Access Compliance Report

Public Rights-of-Way

(Curb Ramps)

Intersection ID: 10889	Main Street: BRIARGROVE_DR	Cross Street: COLBY_PL	Location: SW
ADA ID: 1BA260ACDAD3	Ramp Type: Para	Initial Pass/Fail: Fail	Overall Compliance: No
Severity Score: 13.75			
Codes/Mitigation Info/Possible Solution		Field Measurements/Component Compliance

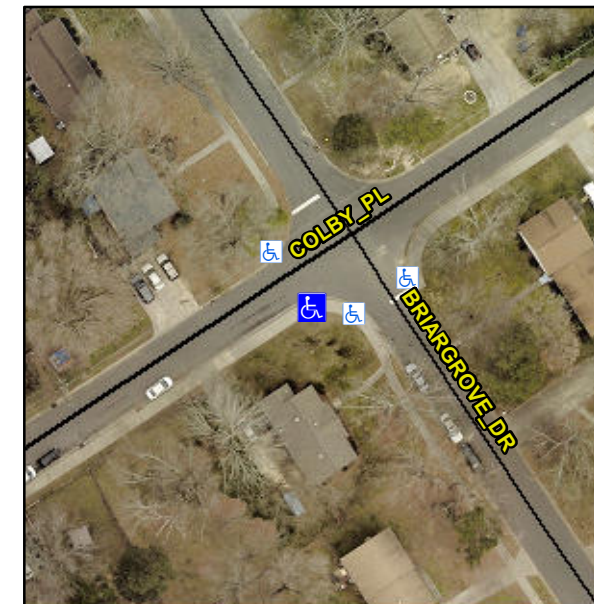
Remove & Replace Entire Ramp.

R304.3.2, R304.5.3

Compliance	Description	Data	Compliance	Description	Data
N/A	Ramp Length LT (in)	55.0	N/A	Ramp Length RT (in)	57.0
Yes	Ramp Width LT (in)	72.0	Yes	Ramp Width RT (in)	72.0
No	Ramp Slope LT (%)	8.6	Yes	Ramp Slope RT (%)	6.5
No	Ramp XSlope LT (%)	4.1	No	Ramp XSlope RT (%)	3.1
N/A	Landing Length (in)	N/A	N/A	DWS Provided?	N/A
N/A	Landing Width (in)	N/A	N/A	DWS Contrast?	N/A
N/A	Landing Slope (%)	N/A	N/A	DWS Length (in)	N/A
N/A	Landing X Slope (%)	N/A	N/A	DWS Full Width?	N/A
N/A	Landing Curb? (Y/N)	N/A	N/A	DWS Offset (in)	N/A
N/A	Shared Landing?	N/A			
N/A	Gutter Ponding?	N/A	N/A	Gutter Slope (%)	N/A
N/A	Gutter Lip Ht (in)	N/A	N/A	Gutter X Slope (%)	N/A
N/A	Painted X Walk1?	No	N/A	Painted X Walk2?	N/A
	X Walk 1 Direction	To NW		X Walk 2 Direction	N/A
N/A	X Walk 1 Width (in)	N/A	N/A	X Walk 2 Width (in)	N/A
	X Walk 1 Slope (%)	1.9		X Walk 2 Slope (%)	N/A
	X Walk 1 X Slope (%)	2.1		X Walk 2 X Slope (%)	N/A
N/A	Ramp inside XWalk1?	N/A	N/A	Ramp inside XWalk2?	N/A
